**MOORE PUBLIC SCHOOLS -
OLD SCHOOL REPLACEMENT**

ADDENDUM NO. 1

April 2, 2026

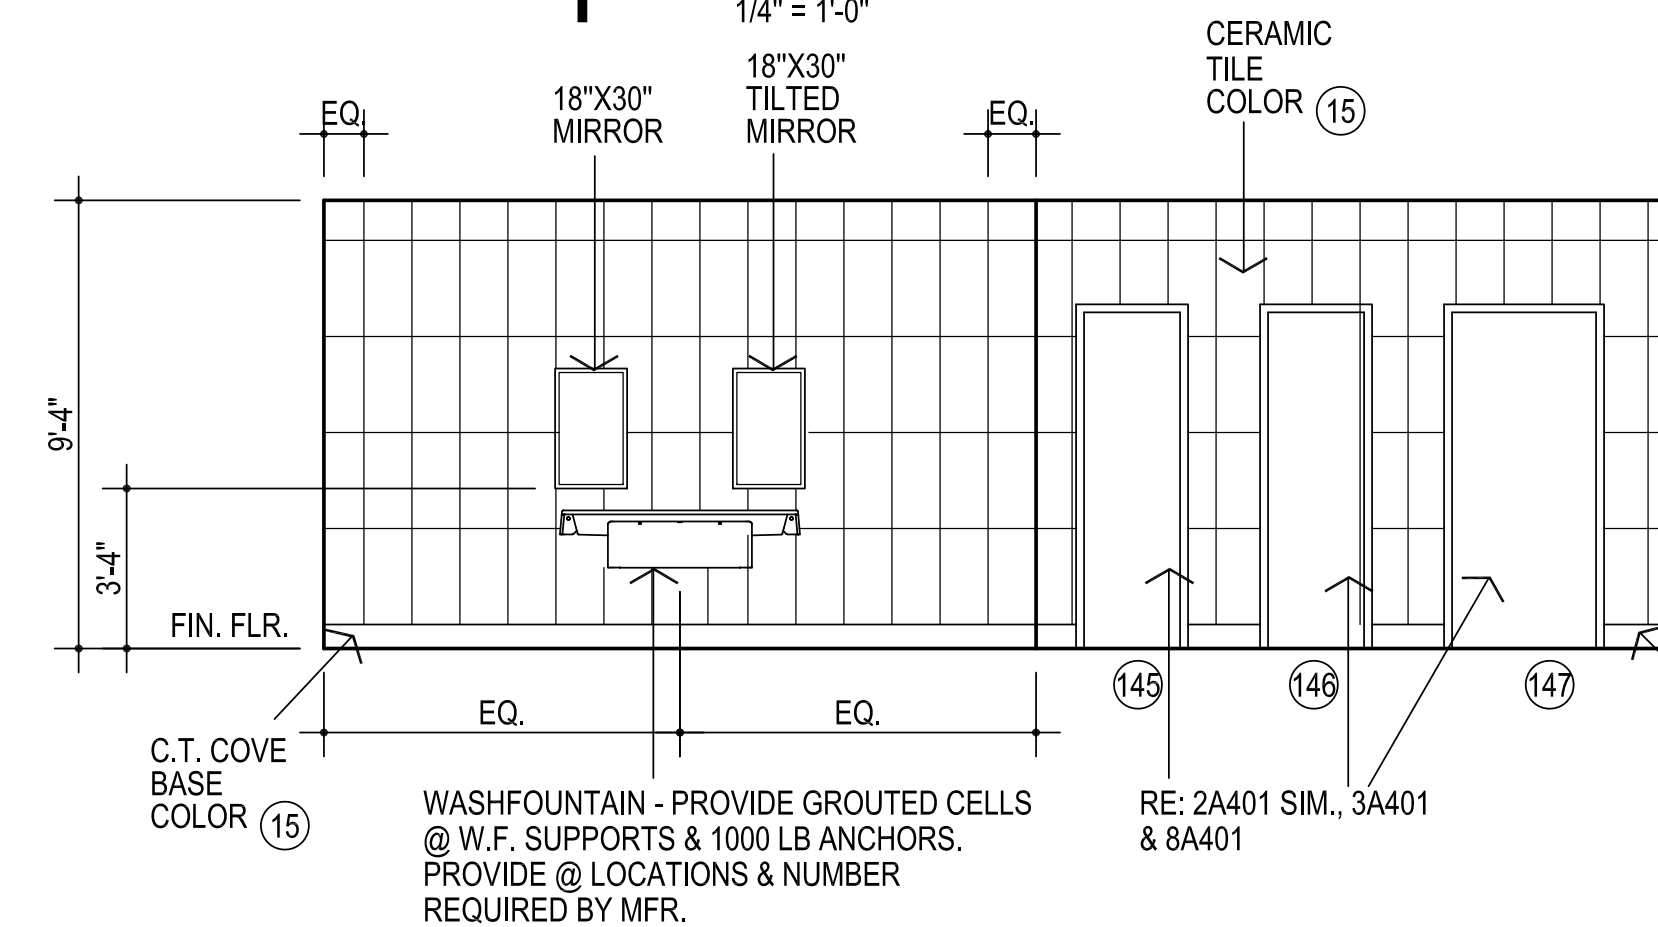
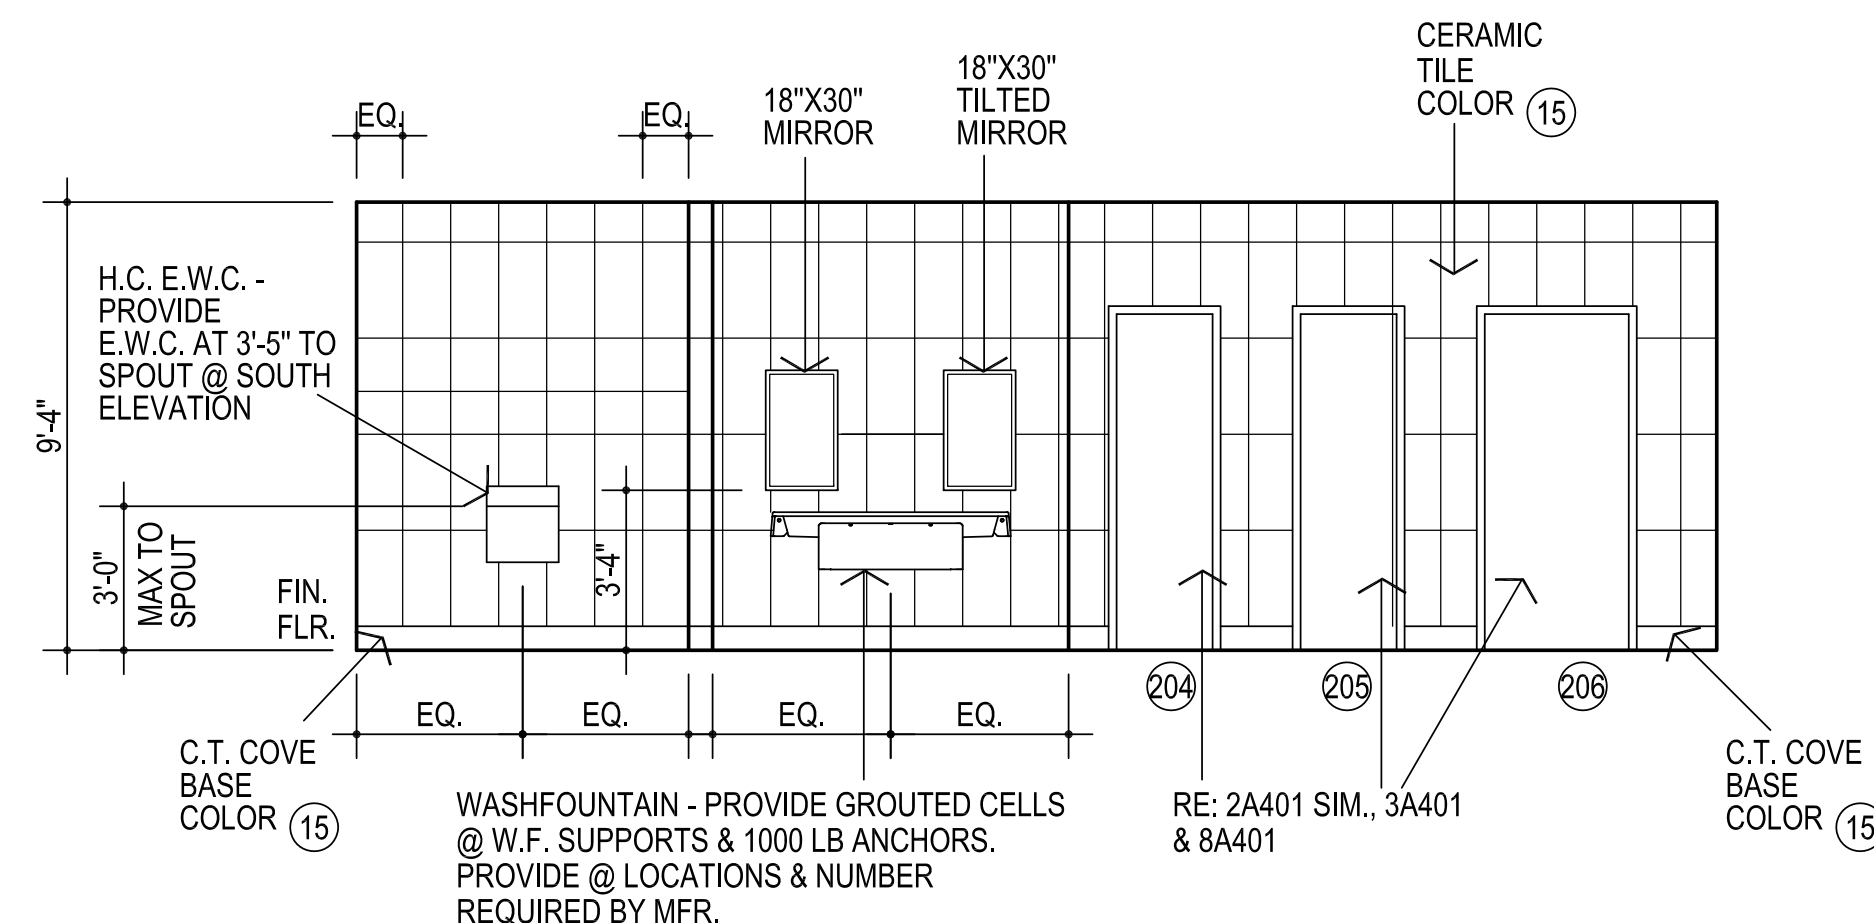
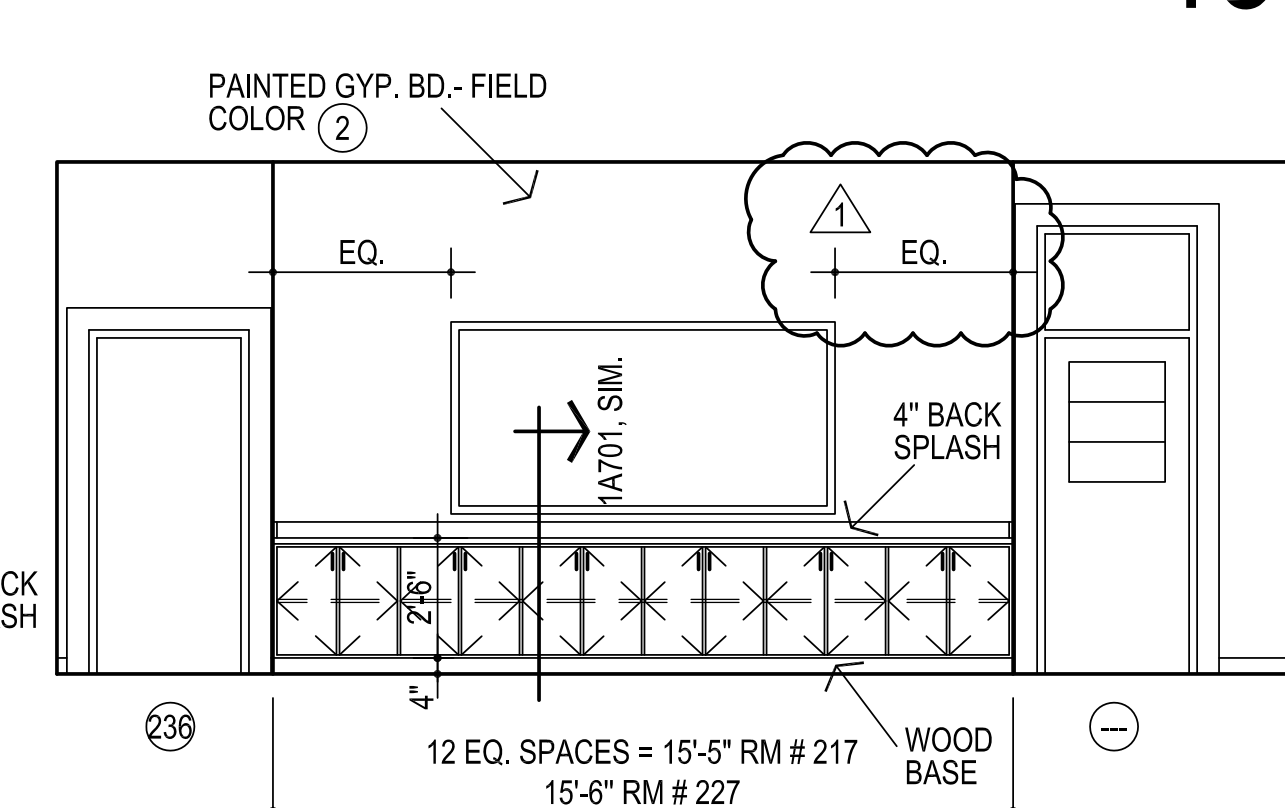
9. Sheet A307, Detail #2, Wall Section and Details #3 & 5, Vertical Details: revise details as indicated. Refer to attached revised drawings.
10. Sheet A401, Details #1, 6, 7, 12, 13, & 17, Interior Elevations: revise interior elevations to indicated tack board locations. Refer to attached revised drawing.

1 FIRST FLOOR DOOR SCHEDULE

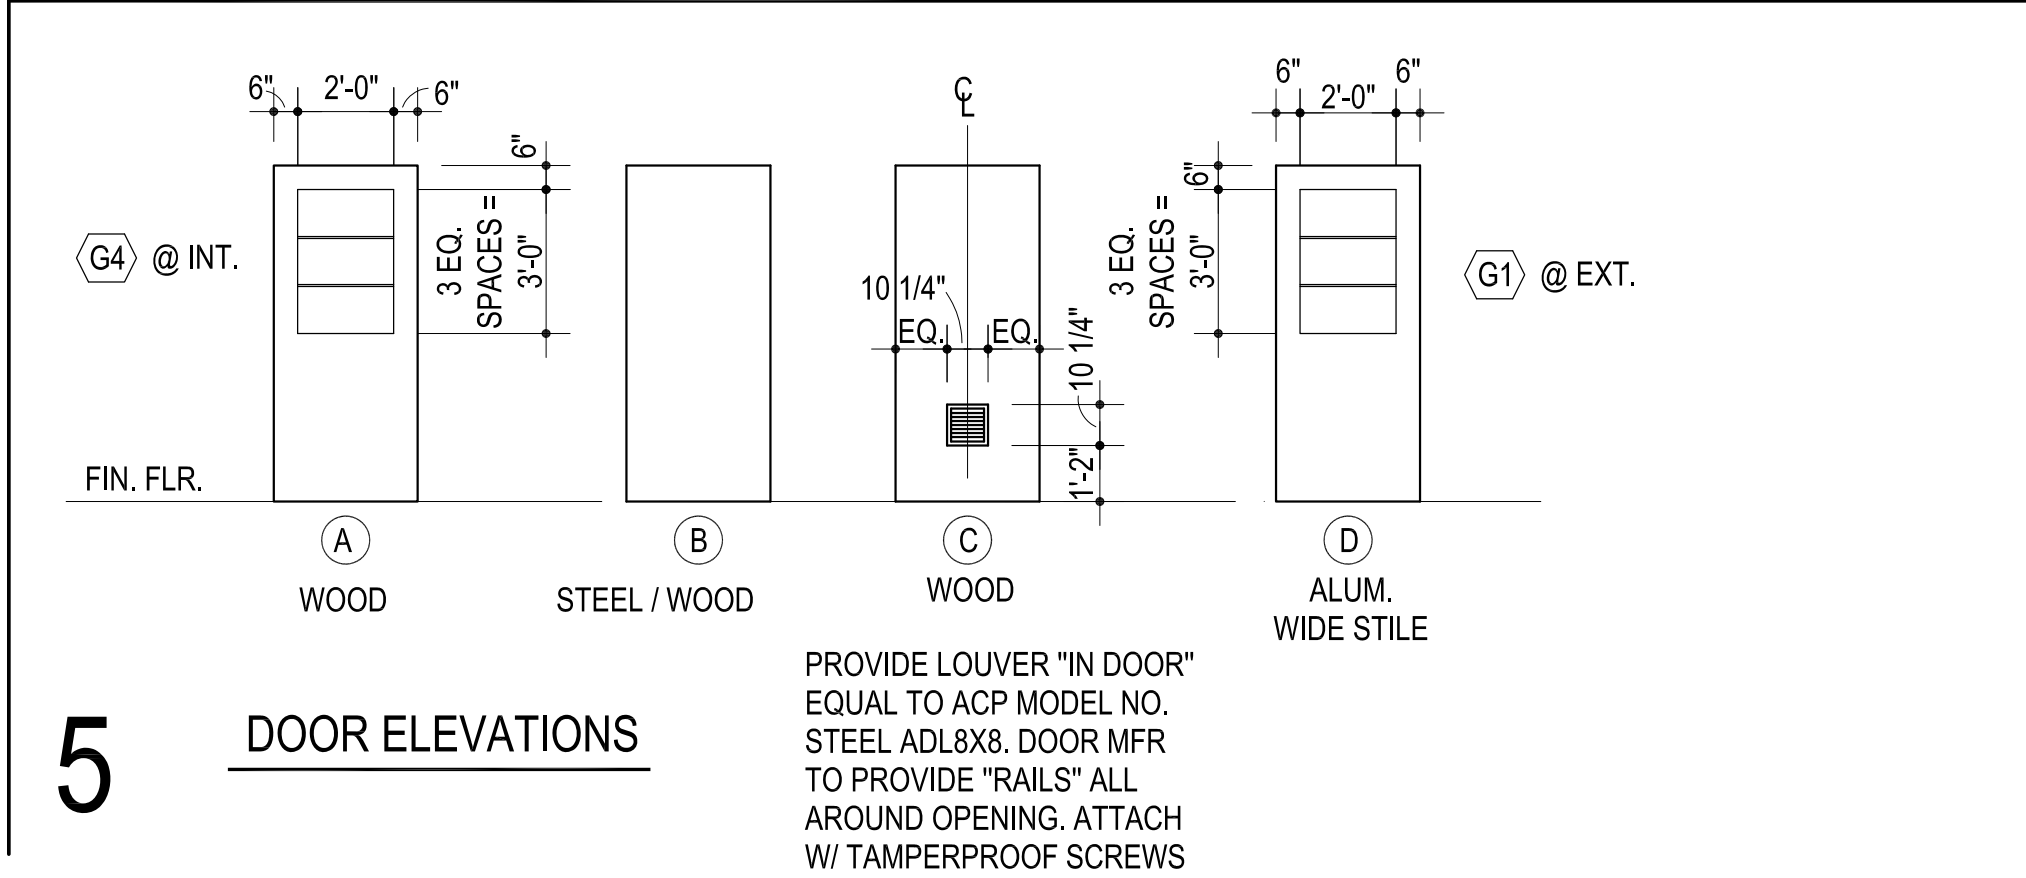
11. Sheet A601, Detail #1, Room Finish Schedule and Detail #2, Color Schedule: revised schedules as indicated. Refer to attached revised drawing.
12. Sheet A602, Detail #1, Door Schedule: revise schedule as indicated. Refer to attached revised drawing.

1 WINDOW ELEVATIONS

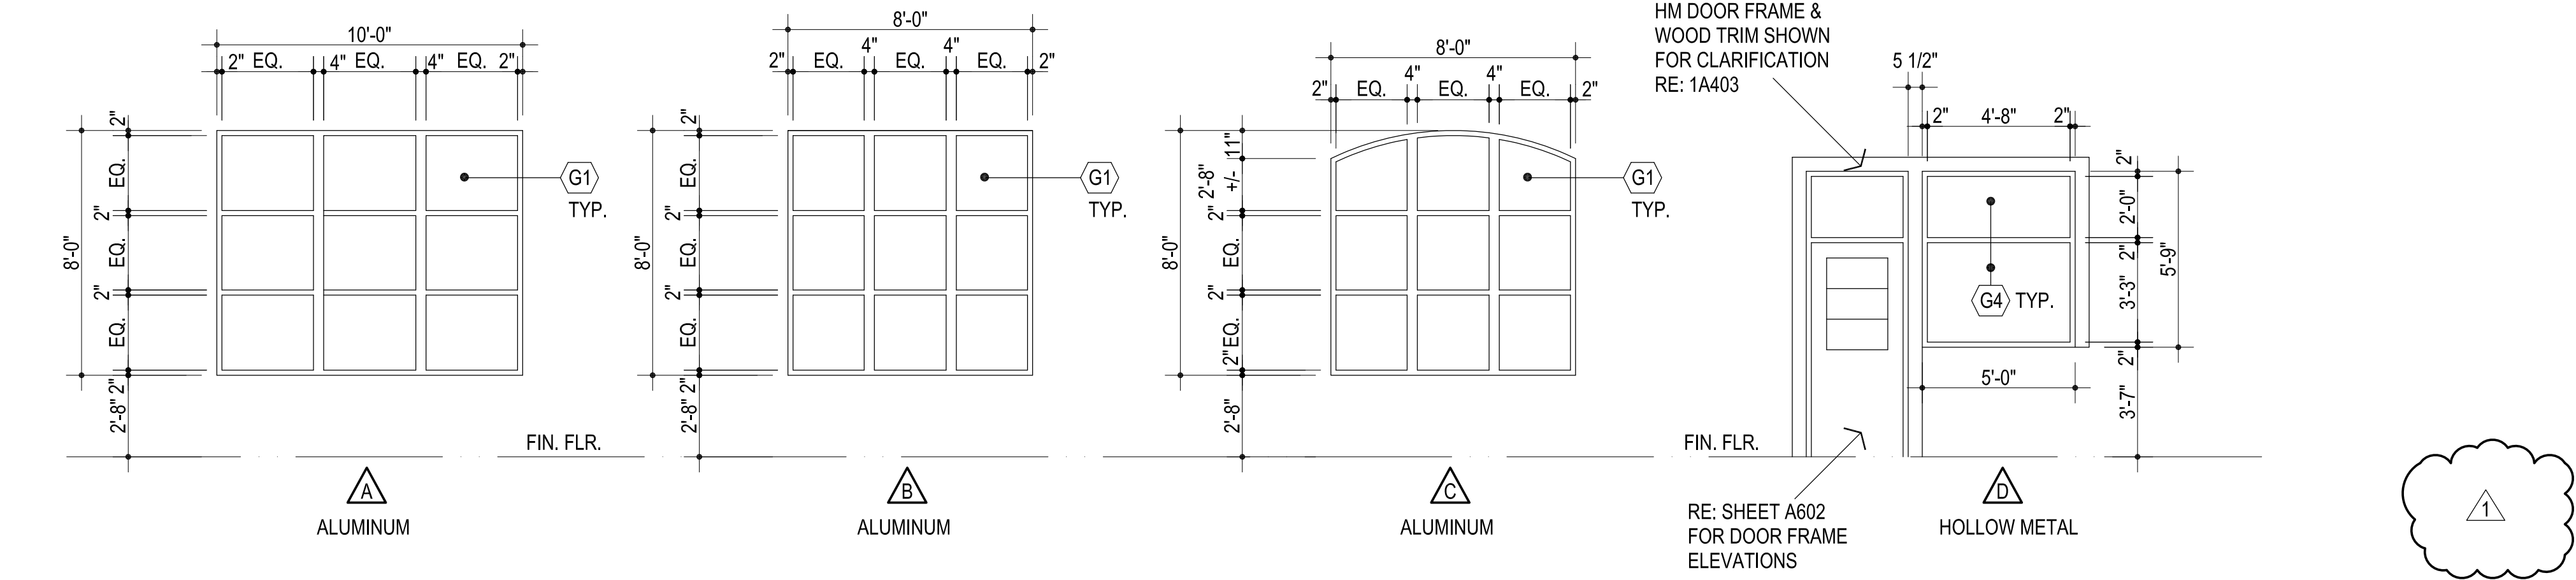
13. Sheet A602, Detail #6, Door Frame Elevations and Sheet A603, Detail #1, Window Elevations: added frame elevation “D” from Sheet A603 to

Sheet 602 as indicated. Refer to attached revised drawing.
